**SERVICE BULLETIN 1A
(Reprint)**

FROM: Pete Gustafson, Field Service Mgr.
TO: Service Managers
DATE: April 12, 1988
RE: Secret Service - Cross Playfield Plunger Shot

FIG. 1

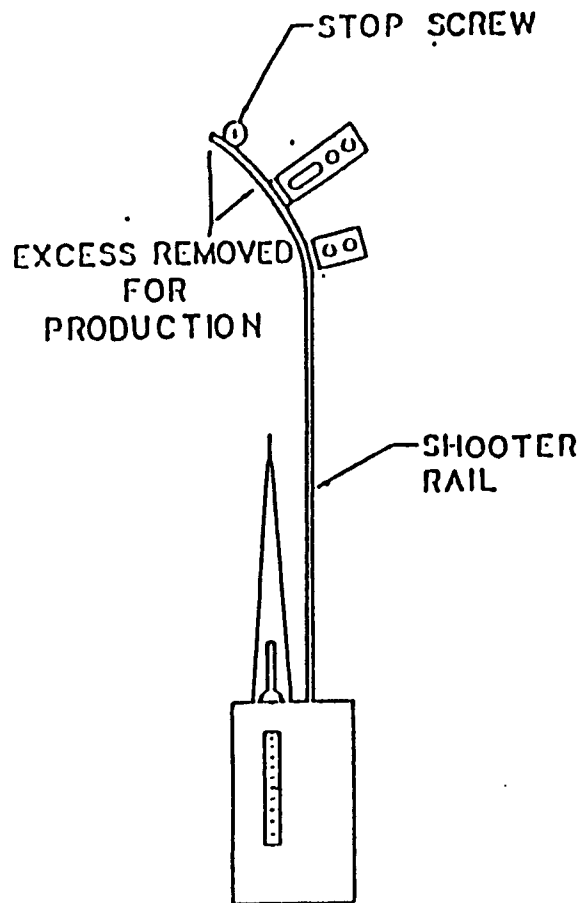
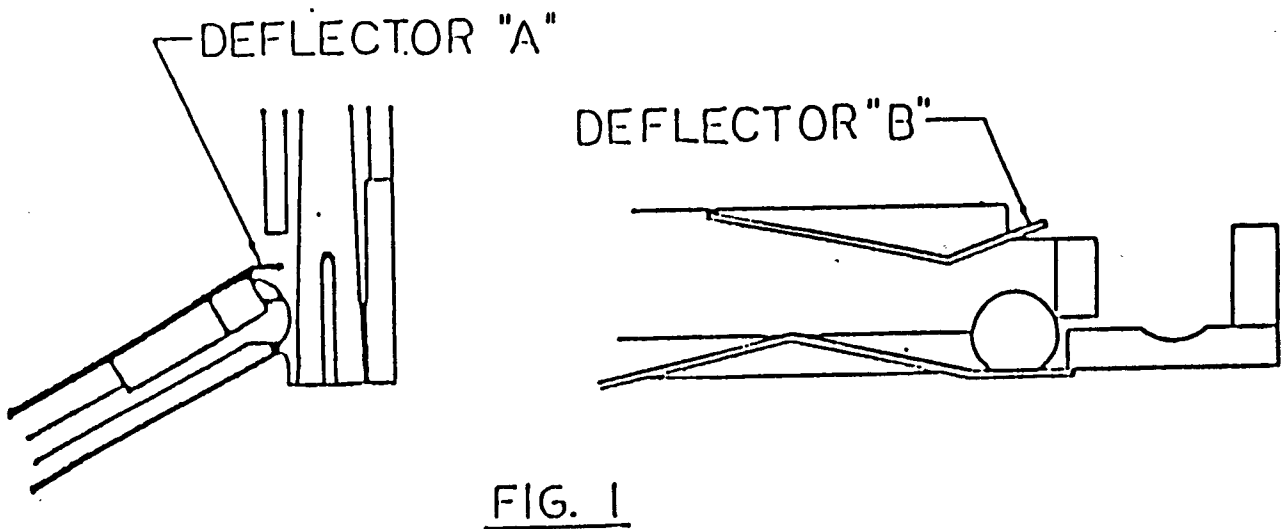
1. The cross playfield shot from the ball shooter is adjustable, but may require premature adjusting due to the excessive length of the shooter ball rail. We have added a hole to the adjustable rail mounting bracket and the rail has been shortened (shown in Fig. 1) for the remainder of production but a stop screw should be installed behind the rail once it is adjusted properly.

2. The ball trough eject may require adjustment due to the ball being kicked into the shooter lane and deflecting back into the trough without reclosing the first trough switch. The adjustable deflection plate shown in Fig. 1 must deflect the ball down and to the rear to correct this problem. Adjust deflector "A" to the rear until the ball slightly deflects off the plate. Adjust deflector "B" downward for the same effect.
